PRELIMINARY ENGINEERING
IMX-080-3(315)128--02-77
POLK COUNTY

PLANS OF PROPOSED IMPROVEMENT ON THE
PRIMARY ROAD SYSTEM
POLK COUNTY
PRELIMINARY ENGINEERING

I-35/80 from IA 141 in Urbandale to E of I-35/80/235
 Northeast Mixmaster System Interchange (NEMM)

FIELD EXAM CHECKLIST

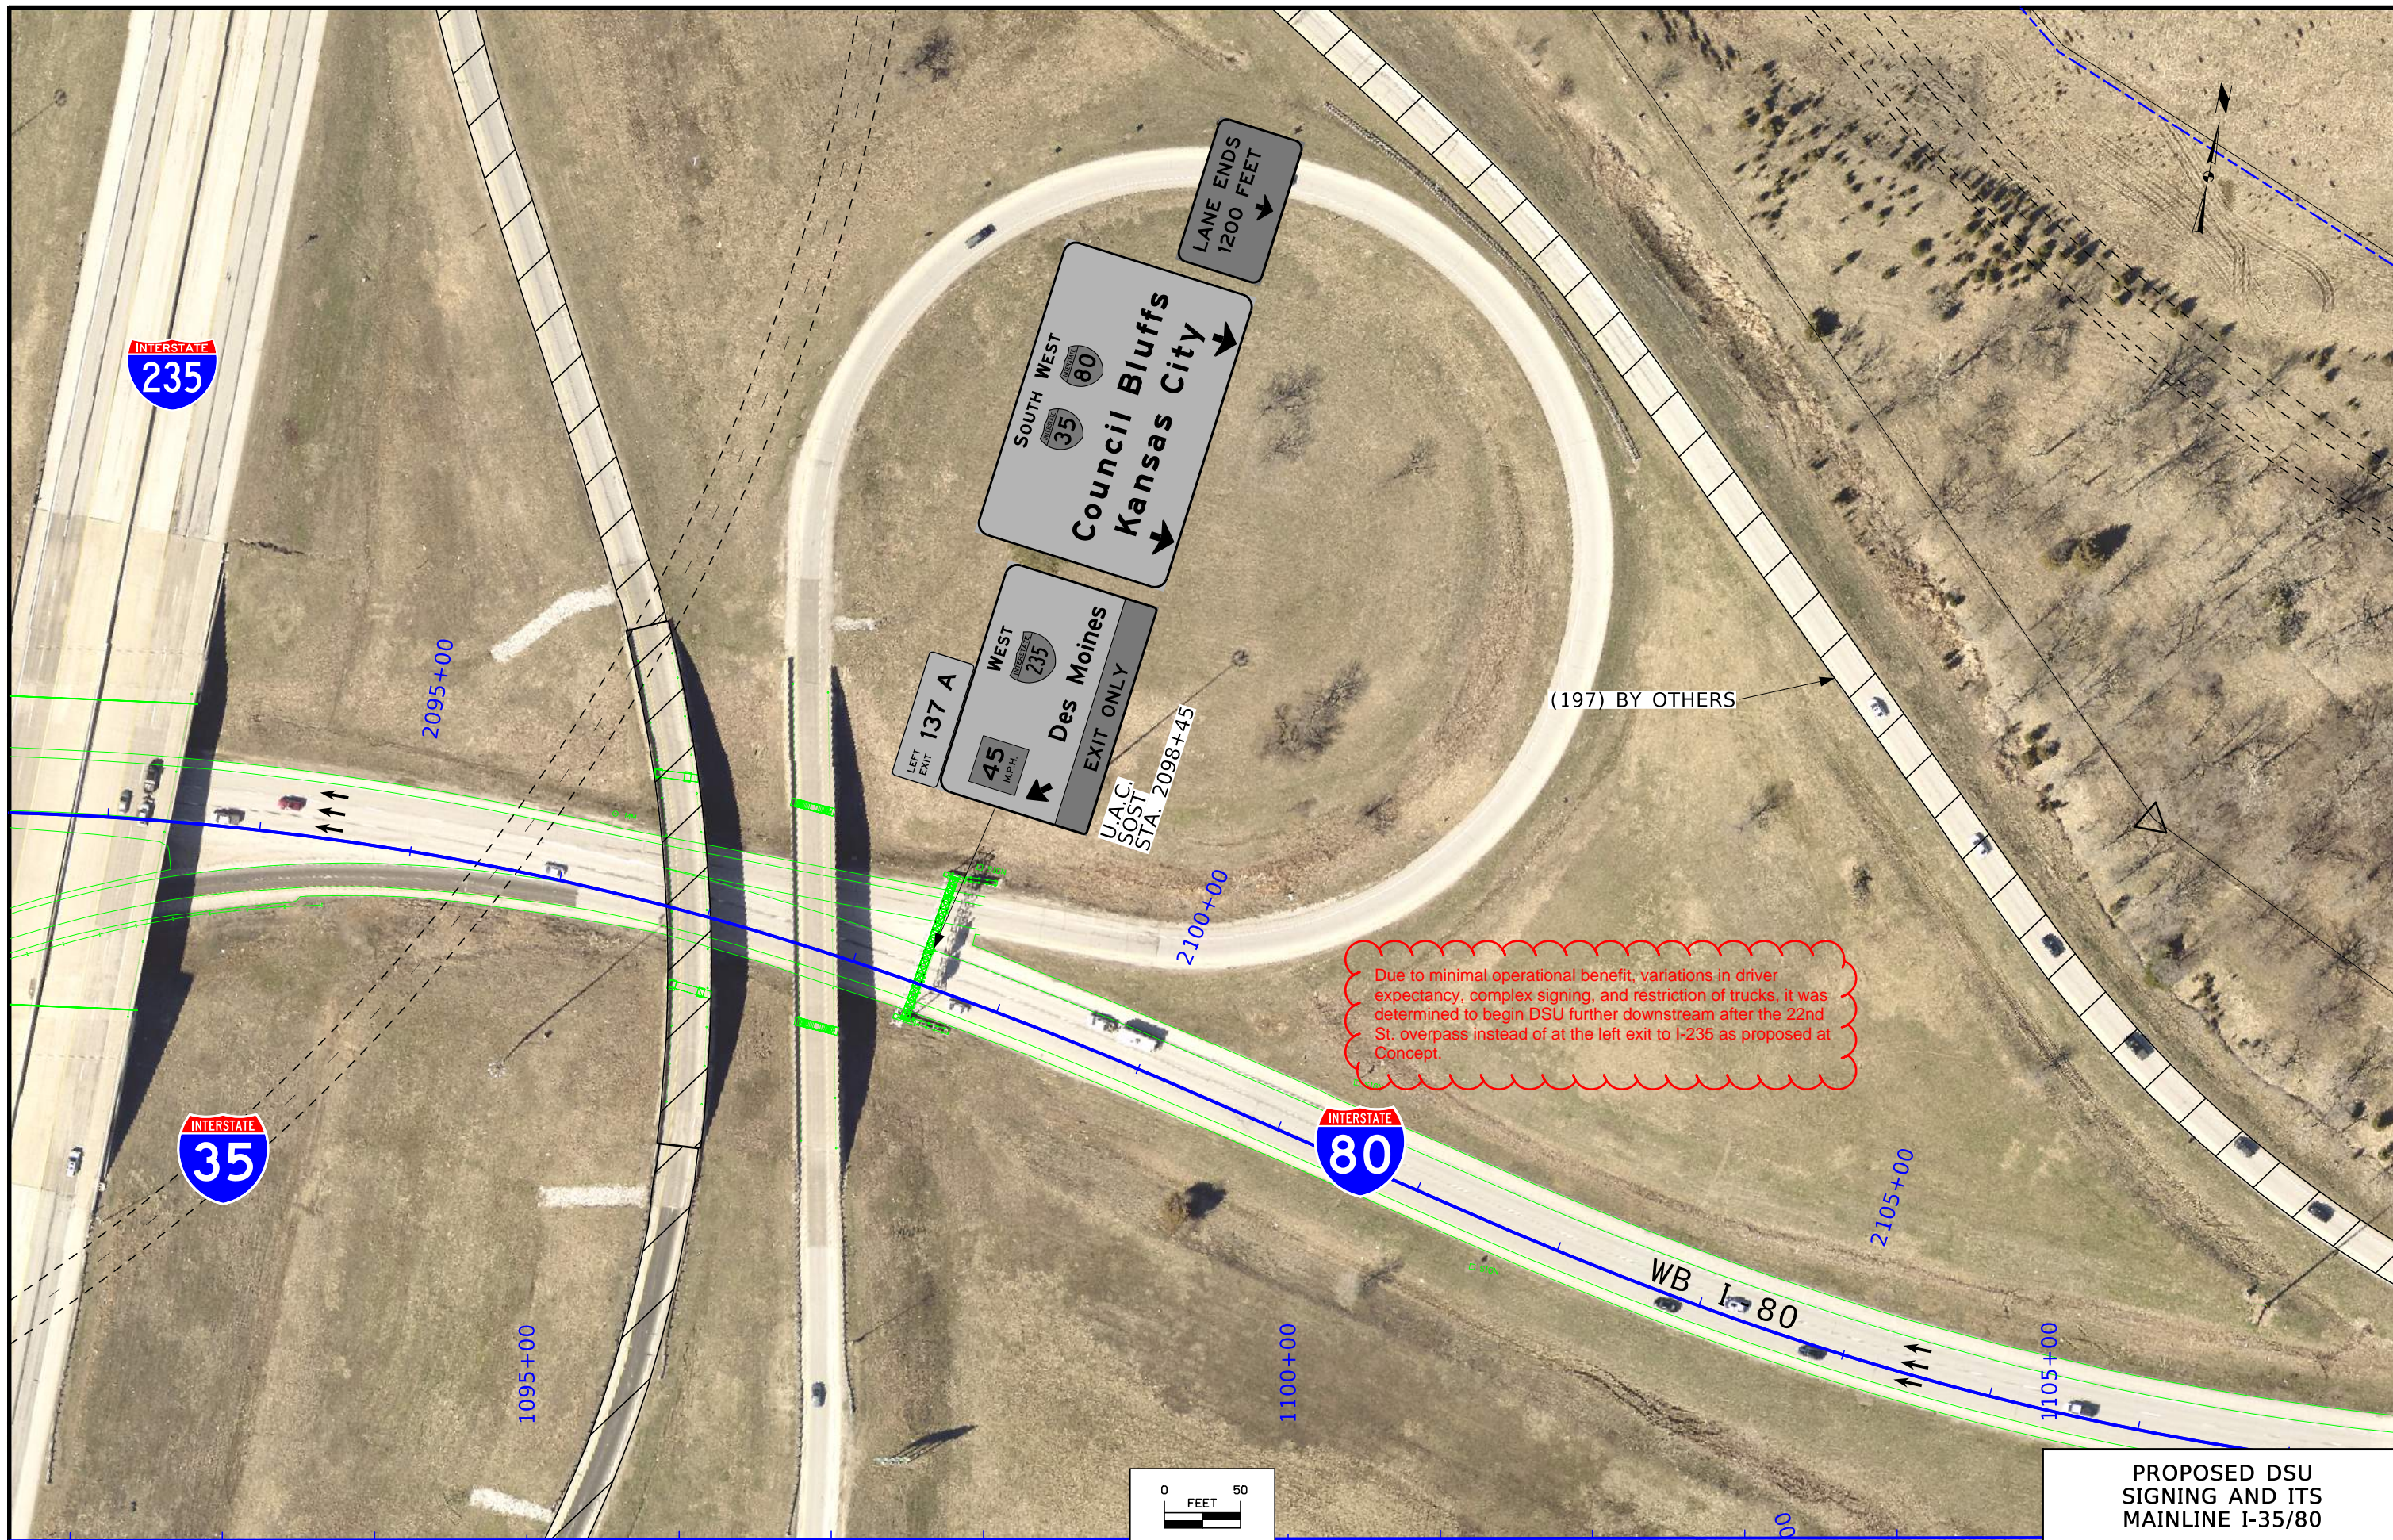
Due to minimal operational benefit, variations in driver expectancy, complex signing, and restriction of trucks, it was determined to begin DSU further downstream after the 22nd St. overpass instead of at the left exit to I-235 as proposed at Concept.

**PROPOSED DSU
SIGNING AND ITS
MAINLINE I-35/80**

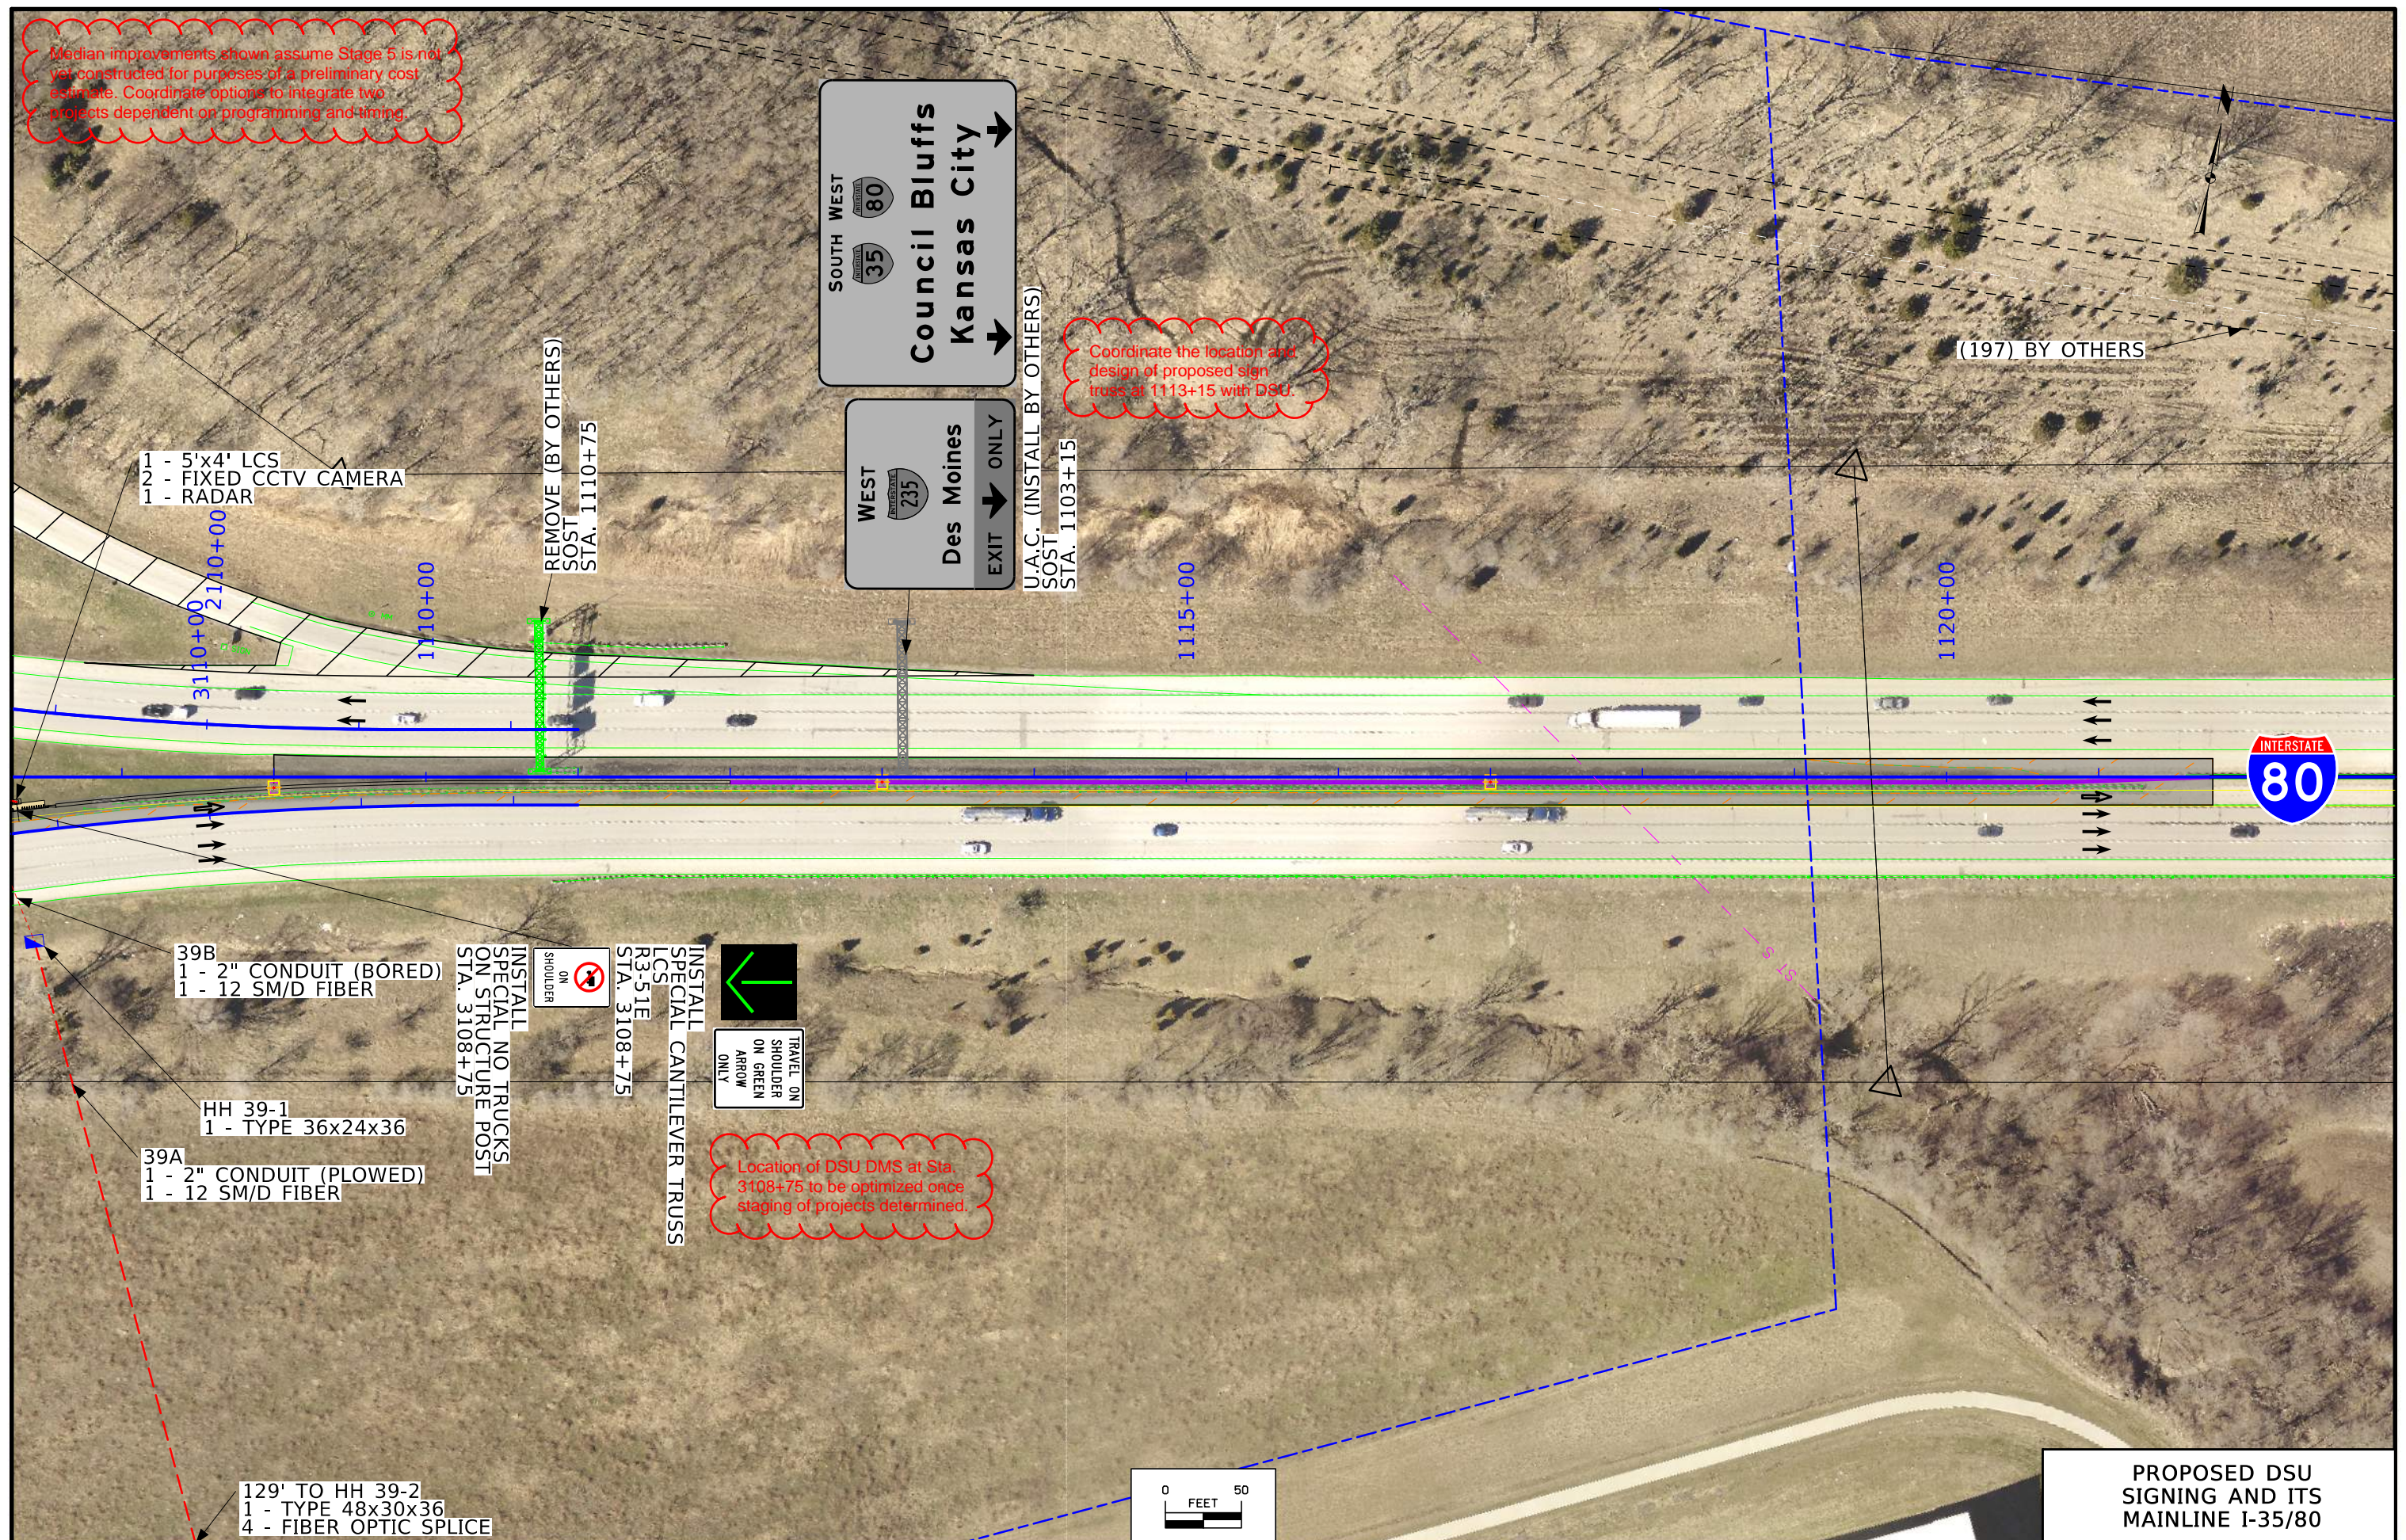
Median improvements shown assume Stage 5 is not yet constructed for purposes of a preliminary cost estimate. Coordinate options to integrate two projects dependent on programming and timing.

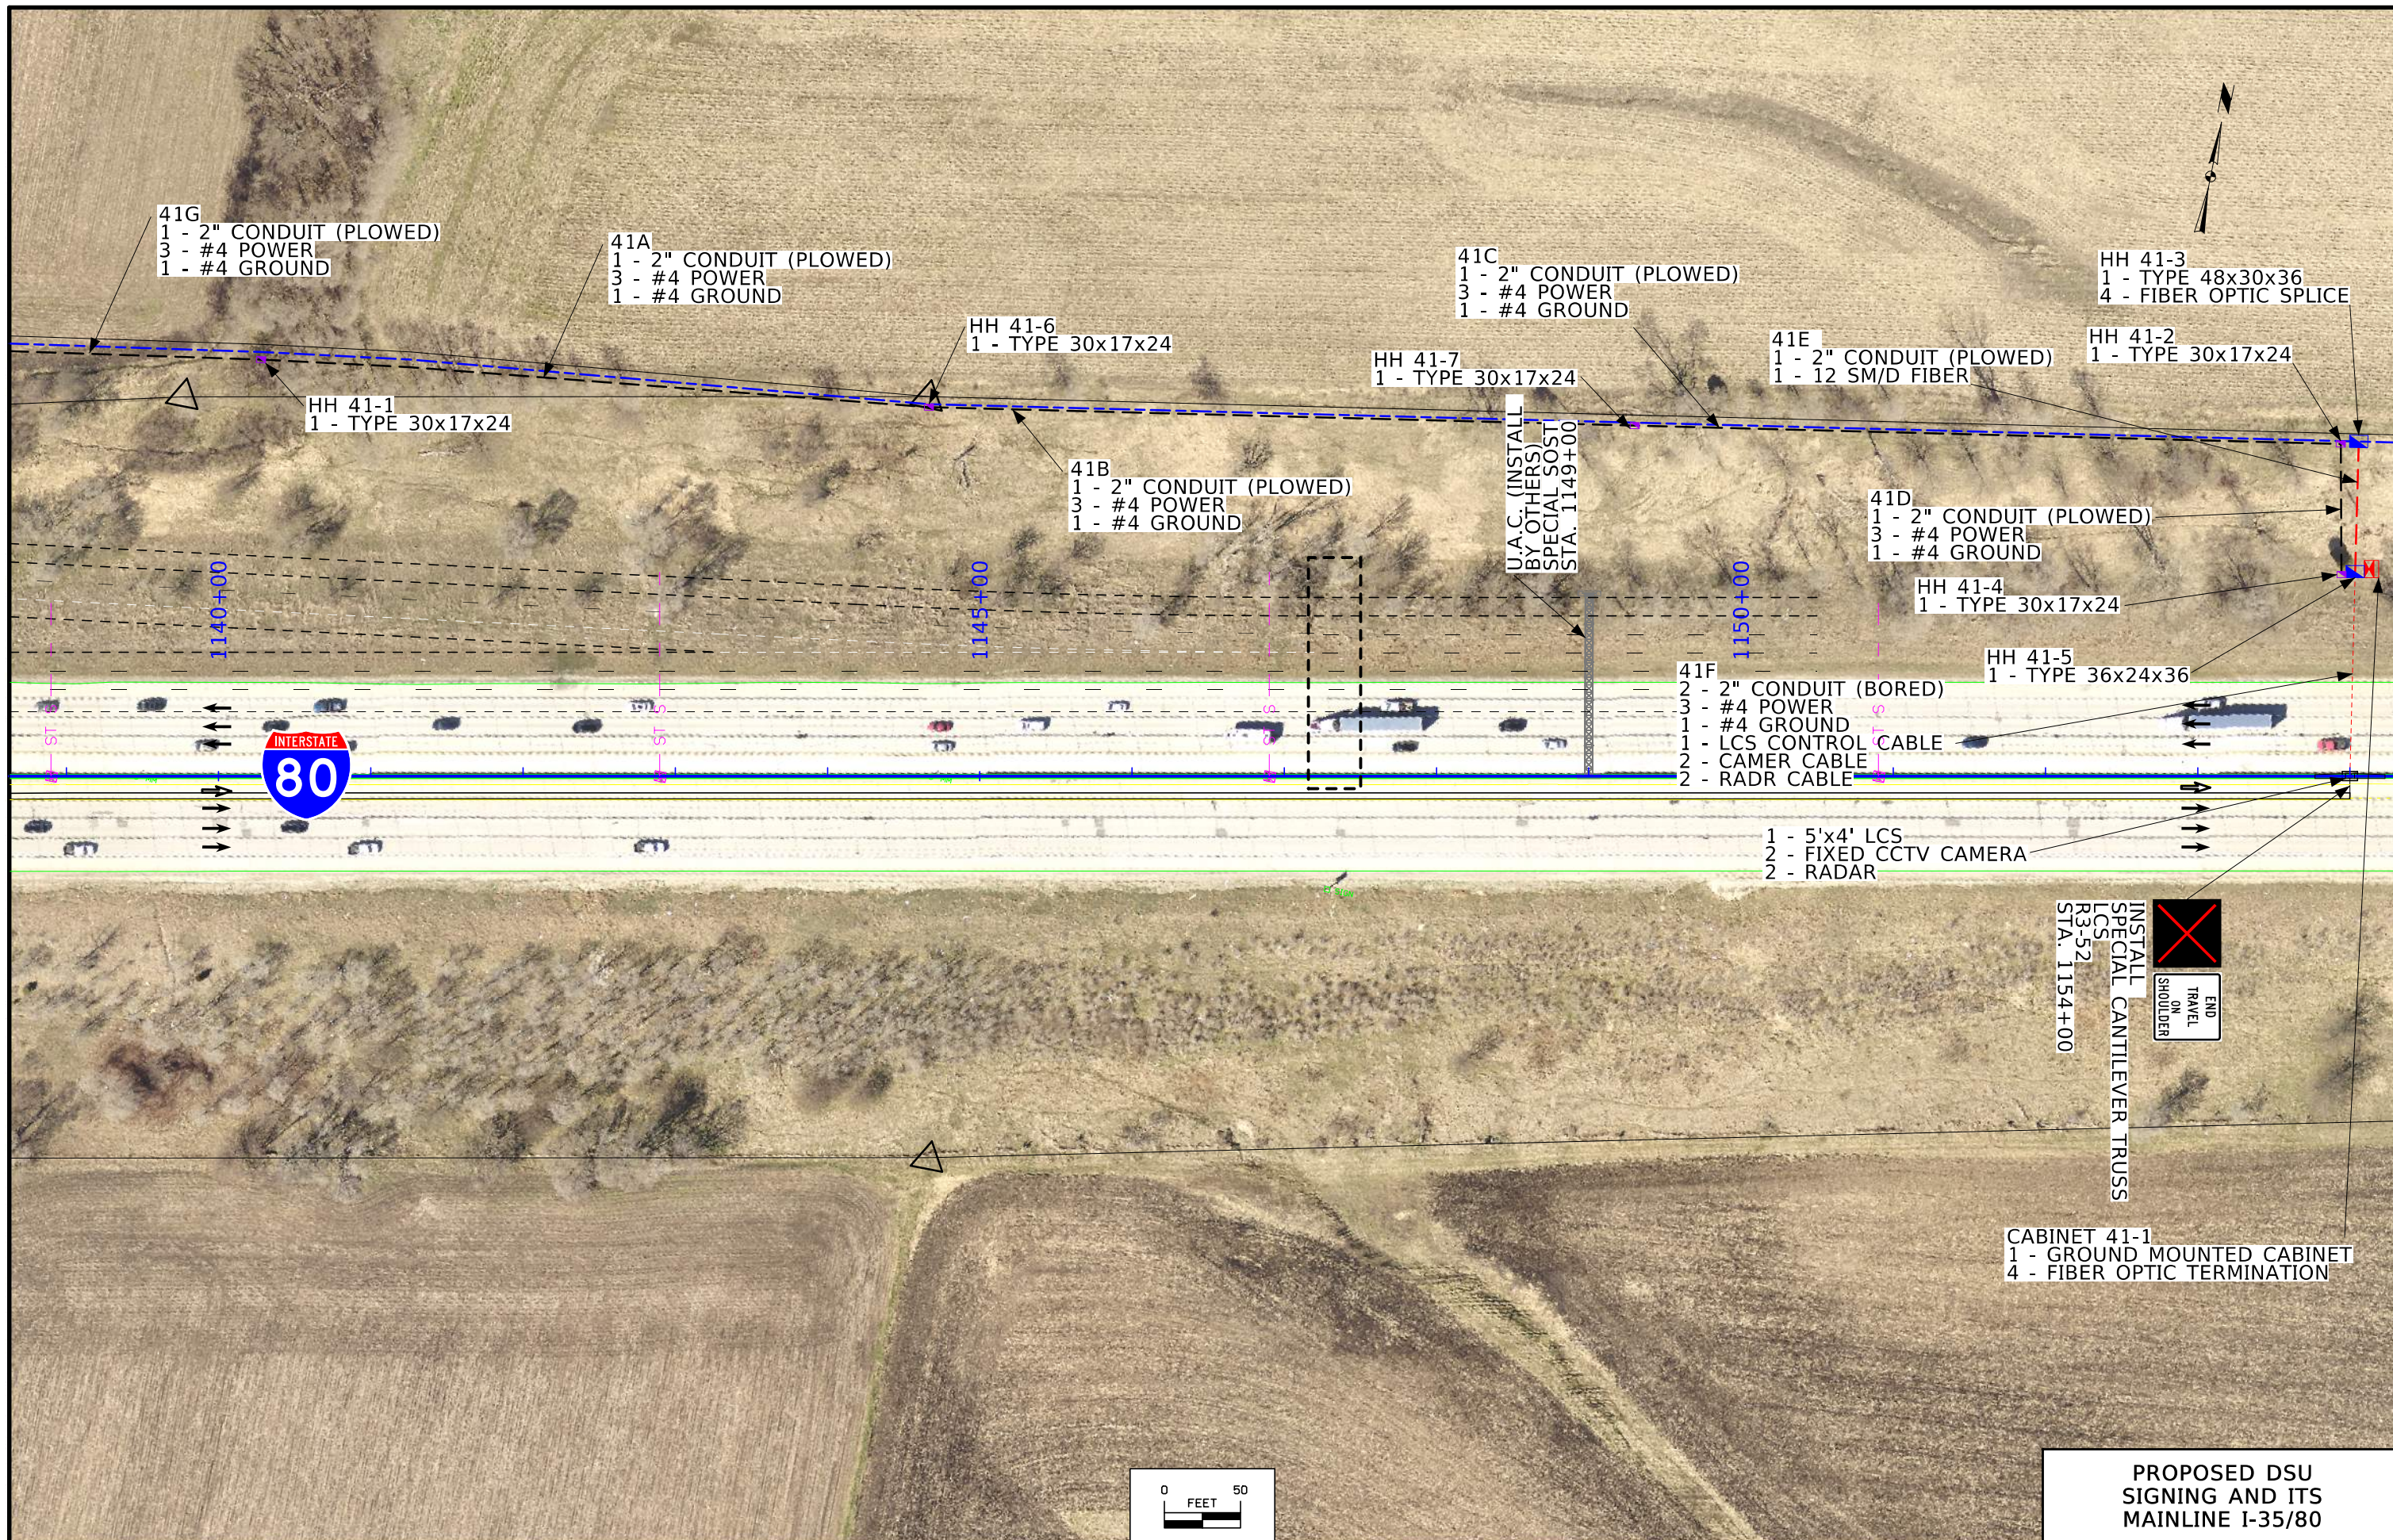
Discuss sign alternatives and Iowa DOT preference for ending DSU (e.g. merge symbol or arrow). Signing shown aligns with draft MUTCD guidance.
